MOONEY SPECIAL LETTER 15-14  
Date: 08-21-2015

- SUBJECT:** To ADVISE MOONEY OWNERS/OPERATORS of the **AMSAFE Service Bulletin SB507592-401-25-01 Issued June 15, 2015 - AmSafe Seat Belt Airbag System Extended Service/Storage Life for TRW Series Inflators (see attached).**

**SB507592-401-25-01**

*AmSafe Seat Belt Airbag System Extended  
Service/Storage Life for TRW Series Inflators*

Figure 1. Sample Label showing expiration date

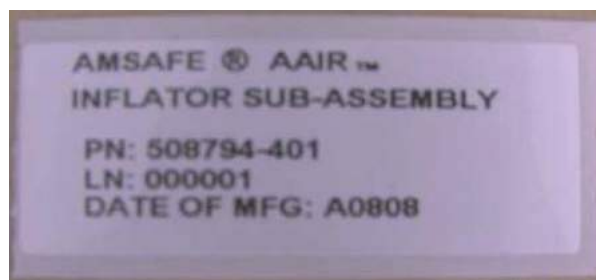
The 12 year service life limit of an inflator with an expiration date, as shown in Figure 1, can be determined by adding two (2) years to the expiration date. If the inflator has an AmSafe label stating the "DATE OF MFG" (see Figure 2) then (12) years from the date shown on the label should be used.

Operators should record this Service Bulletin and issue date in the Service Bulletin section, of the applicable Instructions for Continued Airworthiness (ICA). Note: No changes are to be made to the label on the inflator to denote these new service/storage dates.
